Access Compliance Report

Public Rights-of-Way

(Curb Ramps)

Intersection ID: 3490	Main Street: PRESERVATION_POINTE_DR	Cross Street: TRANQUILLITY_DR	Location: SW
ADA ID: DF12CF7B7F2E	Ramp Type: Perp	Initial Pass/Fail: Fail	Overall Compliance: No
Severity Score: 21.25			
Codes/Mitigation Info/Possible Solution		Field Measurements/Component Compliance

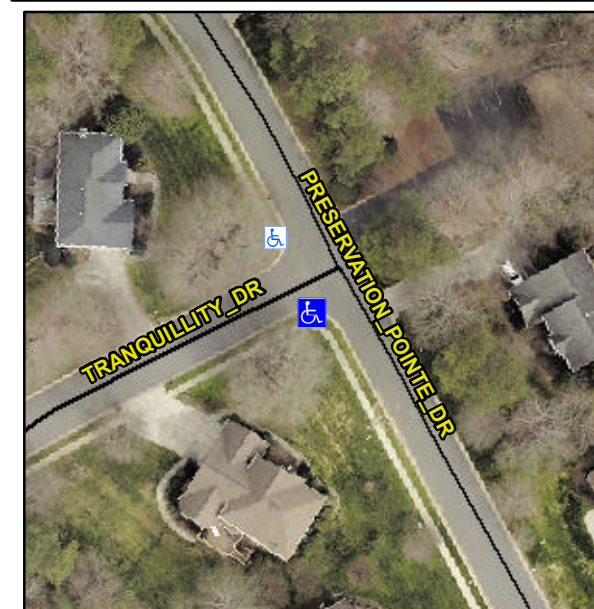
Not Found, R304.5.1, R304.5.3

Compliance	Description	Data	Compliance	Description	Data
N/A	Ramp Length (in)	49.0	Yes	Ramp Slope (%)	6.3
No	Ramp Width (in)	47.0	No	Ramp XSlope (%)	6.3
N/A	Flare Type LT	N/A	N/A	Flare Type RT	N/A
N/A	Flare Slope LT (%)	N/A	N/A	Flare Slope RT (%)	N/A
N/A	Flare Traversable LT?	N/A	N/A	Flare Traversable RT?	N/A
N/A	Landing Length (in)	N/A	N/A	DWS Provided?	N/A
N/A	Landing Width (in)	N/A	N/A	DWS Contrast?	N/A
N/A	Landing Slope (%)	N/A	N/A	DWS Length (in)	N/A
N/A	Landing X Slope (%)	N/A	N/A	DWS Full Width?	N/A
N/A	Landing Curb? (Y/N)	N/A	N/A	DWS Offset (in)	N/A
N/A	Shared Landing?	N/A			
N/A	Gutter Ponding?	N/A	N/A	Gutter Slope (%)	N/A
N/A	Gutter Lip Ht (in)	N/A	N/A	Gutter X Slope (%)	N/A
N/A	Painted X Walk1?	No	N/A	Painted X Walk2?	N/A
	X Walk 1 Direction	To NW		X Walk 2 Direction	N/A
N/A	X Walk 1 Width (in)	N/A	N/A	X Walk 2 Width (in)	N/A
	X Walk 1 Slope (%)	1.0		X Walk 2 Slope (%)	N/A
	X Walk 1 X Slope (%)	4.5		X Walk 2 X Slope (%)	N/A

Remove & Replace Entire Ramp.
